ATTENTION Chris Ritchie
NSW Planning
23-33 Bridge Street
COMPANY Sydney NSW 2000
FROM Bob Meyer
DATE 23th May 2011
SUBJECT Jacfin Horsley Park Project (10_0129 and 10_0130)

Burley Road Subdivision – Review of Wilkinson Murray Acoustic Assessment

CP015 Indicative Cut and Fill

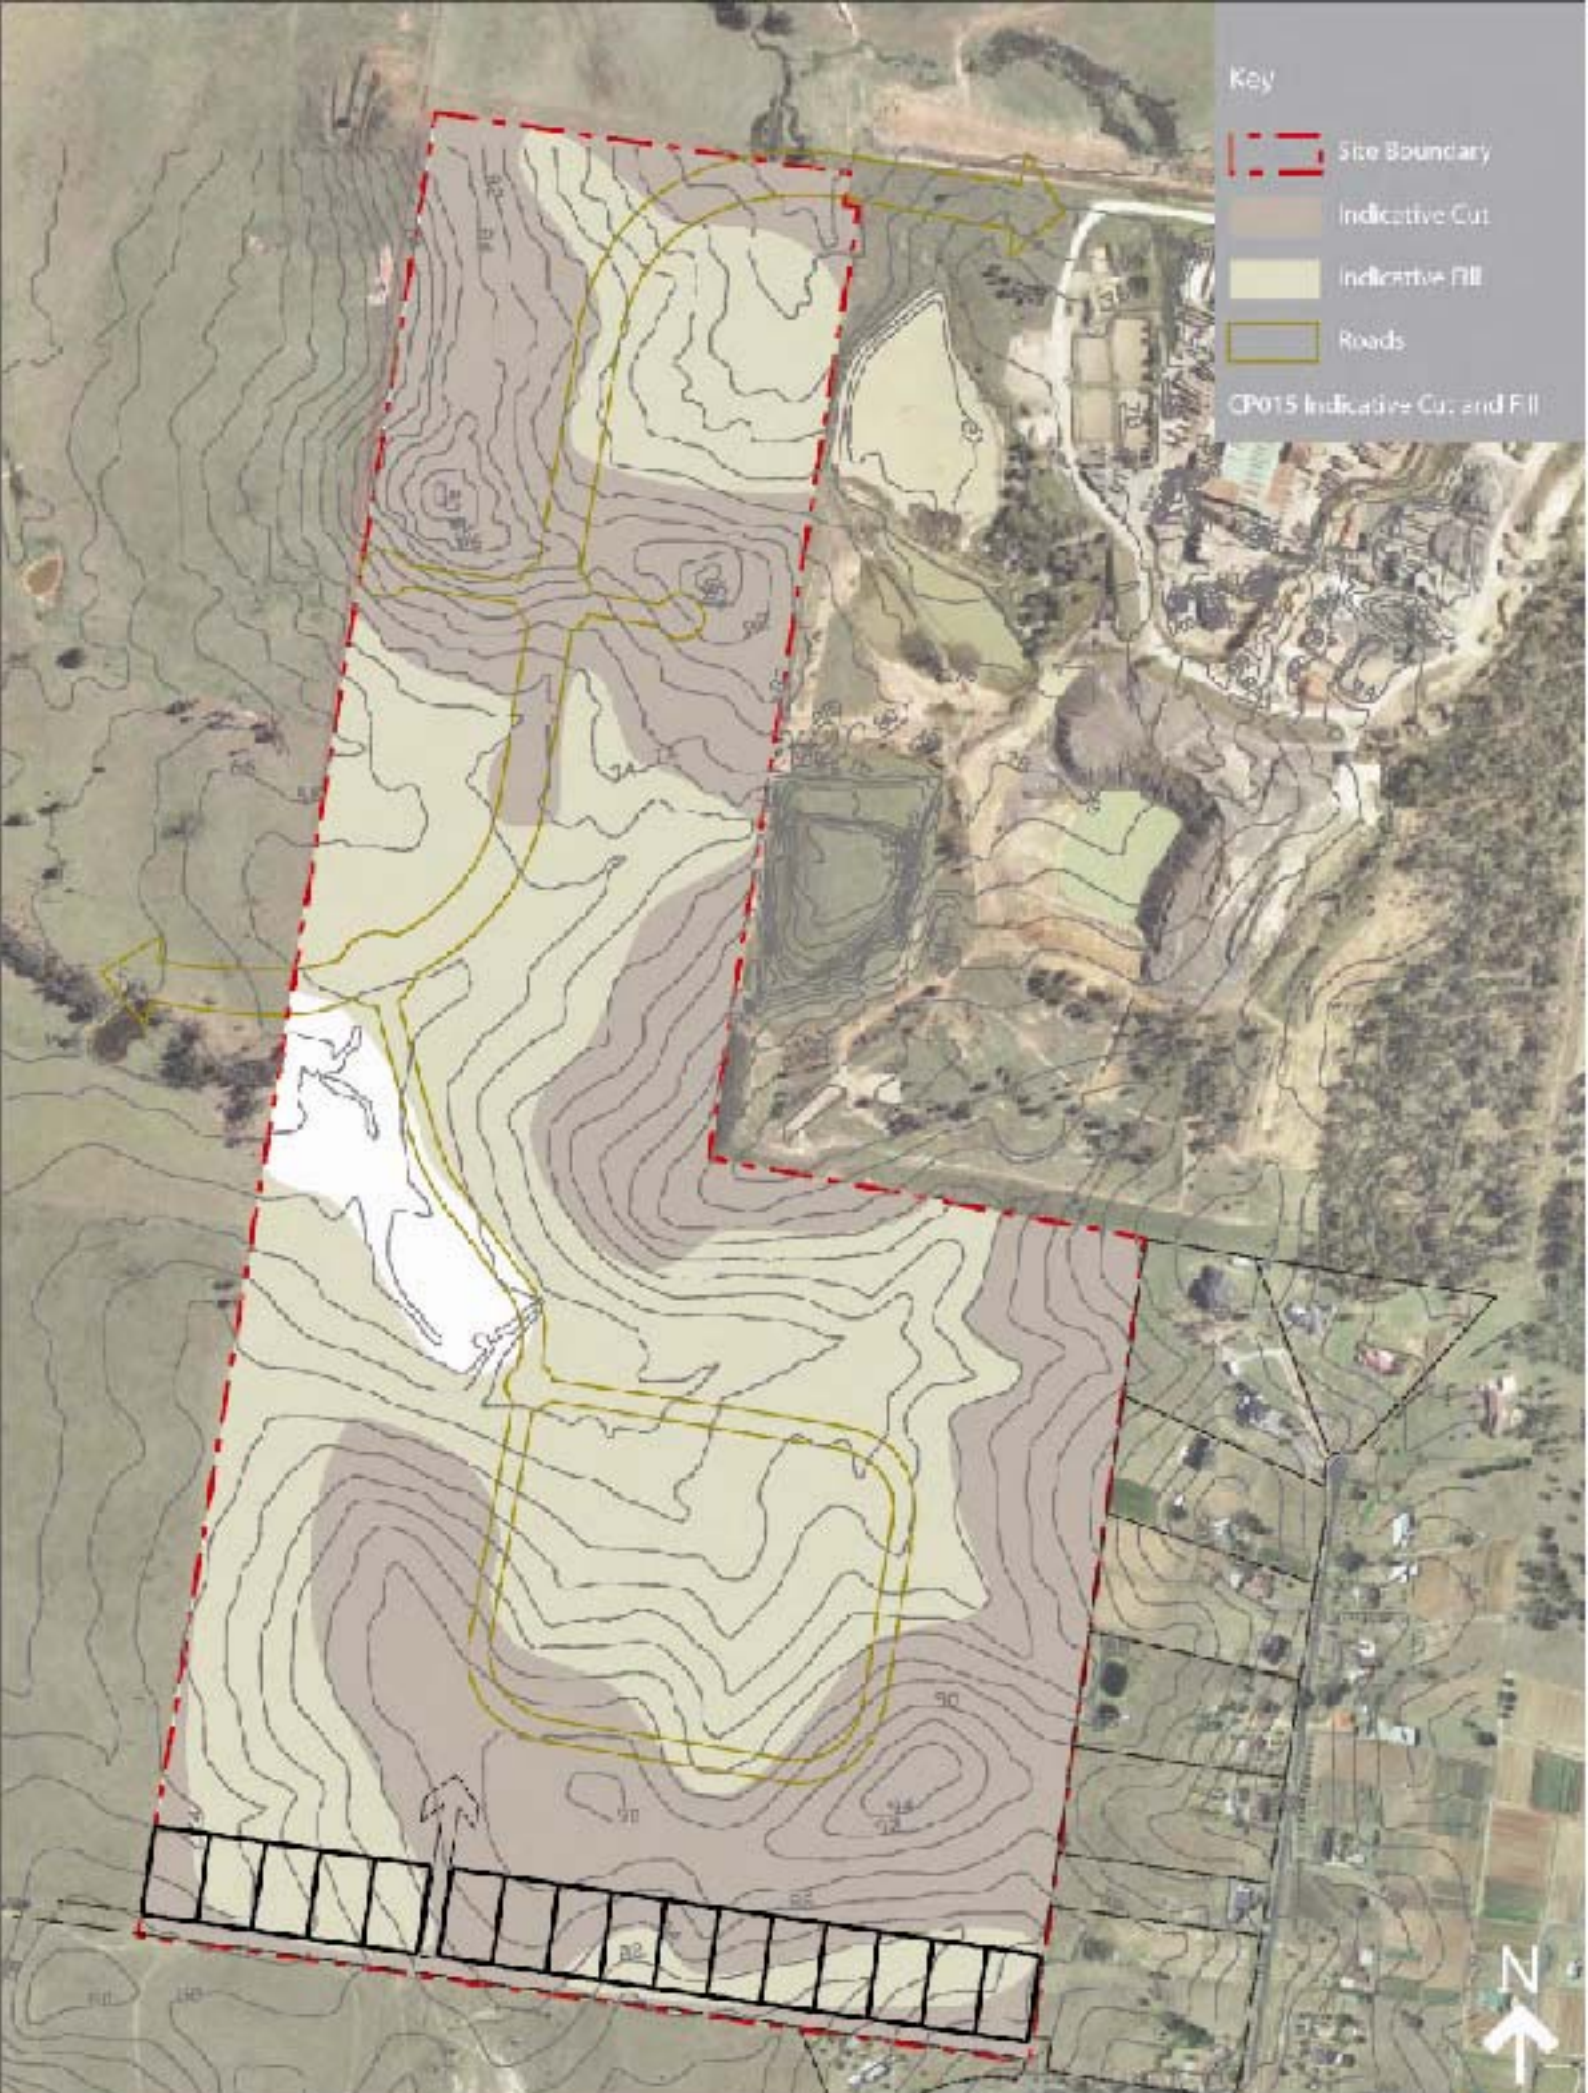
- The Horsley Park Industrial precinct seeks approval for earthworks to cut/fill the land to a proposed RL of 75. Whilst the report is for the stage 1 constituent, it is suggested that the entire site is lowered / raised to an **RL of 75**. At the southern end of the site, this can result in a significant RL change of up to **19m**.

- Council may want to consider the natural topography of the land as it is. There are natural slopes towards the southern boundary which could be used as an acoustic / visual barrier towards the proposed residential land at Capitol Hill.
- Should council approve the ‘Bulk Earthworks’, possibly some consideration should be taken to “shifting” the hill further south, allowing for more developable area as well as providing a buffer between to the incompatible uses.

Figure 1 Concept Plan used for WMPL Acoustic Assessment**Figure 18 – Proposed Concept Plan**

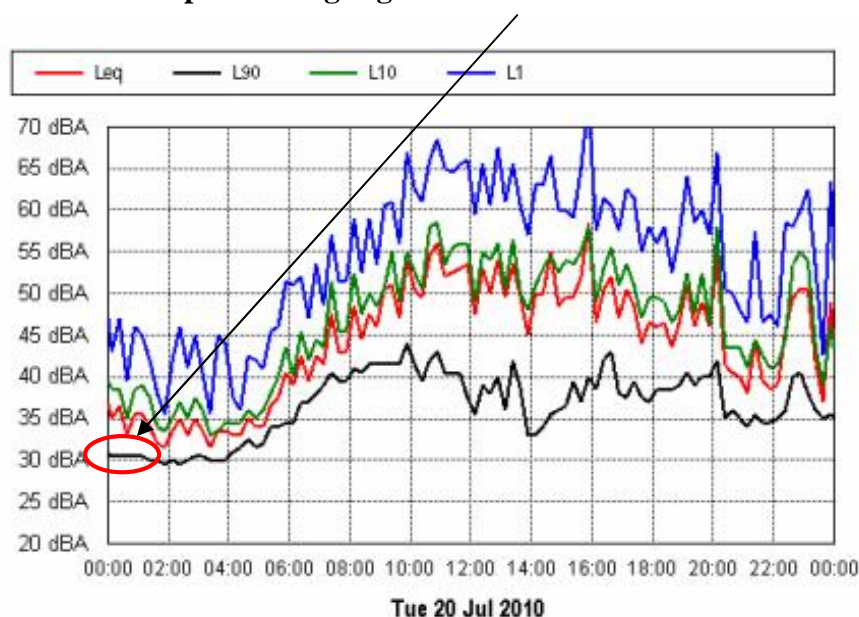
The WMPL Report is based upon the following concept plan, see Figure 1, which is taken from the *Environmental Assessment Report*.

- A. There is insufficient information provided to enable the predicted noise emission to be checked in even a cursory way. For example, the height of the warehouse buildings assumed to be noise barriers is not explicitly stated and the presumed locations of loading docks etc, as used in the acoustic predictions described, are not shown in sufficient detail.

- F. The predicted noise levels in Section 7 of the WMPL Report assume shielding via buildings as indicated in Figure 1-2 of that Report. It will take time for these buildings to be constructed and until they are all in place, the actual noise shielding will be less than assumed in the noise prediction model.

- I. The main issue to be addressed is whether the Concept assumed in the Acoustic Report is adequate. The Environmental Assessment Report – in Section 4.5 of Volume 1, and in Section 2.1 of Appendix L – nominates potential Lot sizes much smaller than those shown in the Concept Plan that was used for the Acoustic Assessment. For example, 1,500m² is nominated as the minimum Lot size in Section 4.5 and 2,000m² is nominated as the minimum Lot size in Appendix L.

The WMPL Noise and Vibration Report was based on Lot sizes of approximately 30,000 to 50,000m². The potential number and location of noise sources was based on only 20 or so of these large Lots, as shown in the Concept Plan. The proponent wants to retain flexibility to adapt the site as market conditions may vary in the future and so has nominated minimum Lot sizes of 1,500 or 2,000m² (it is not clear which).

Figure 27 – Areas of Cut and Fill

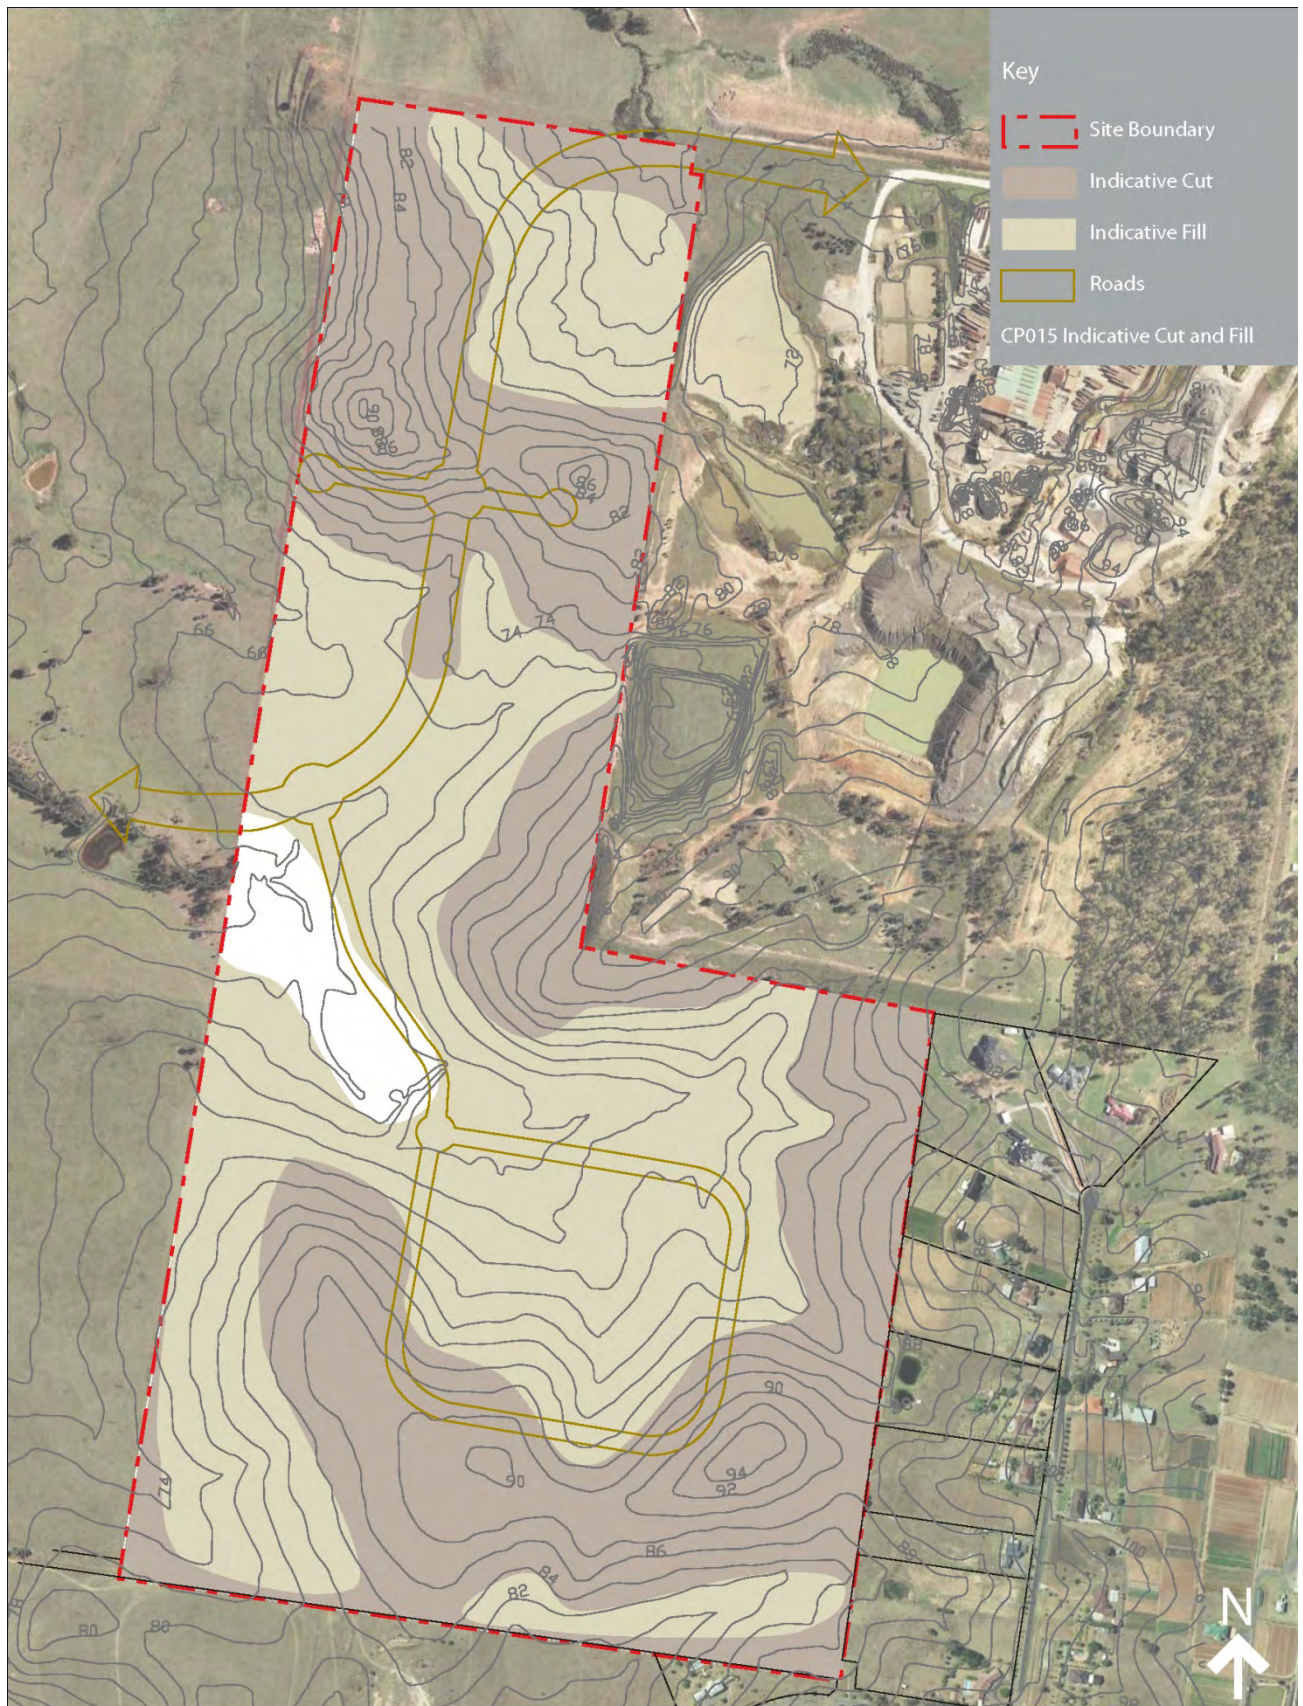
A reasonable proposal would consider how to locate development in a way that satisfies the requirements of Clauses 21 and 23 of SEPPWSEA without destroying the amenity and views of virtually every adjacent residential property. The sensitivity that is the highest on the plan at Figure 39 is land that is proposed to be cut in the Areas of Cut and Fill Plan (Figure 27 at Page 33 of the EAR).

The cut and fill diagram shows virtually none of the site will escape from landform modification. However since the original topography is shown at one scale and contour interval (Figure 13) and the cut and fill is shown at another (Figure 27), while there is no final landform plan that shows the internal topography or the cuts and fills that are presumably around the perimeters, it is difficult to ascertain precisely what is proposed.

However this is by no means the end of the matter with regard to topography. Leaving aside the issue of whether deep cuts are appropriate at the eastern boundary at all, for the moment, the depth of cut shown on the plans does not appear to accord with the descriptions in the EAR. The EAR claims that building footprints are intended to be up to 13-18m below the levels of dwellings in Greenway Place, whereas interpretation of the contour and cut and fill plans seems to indicate that the nearest buildings may be as little as 3-4m below the levels of some of the dwellings.
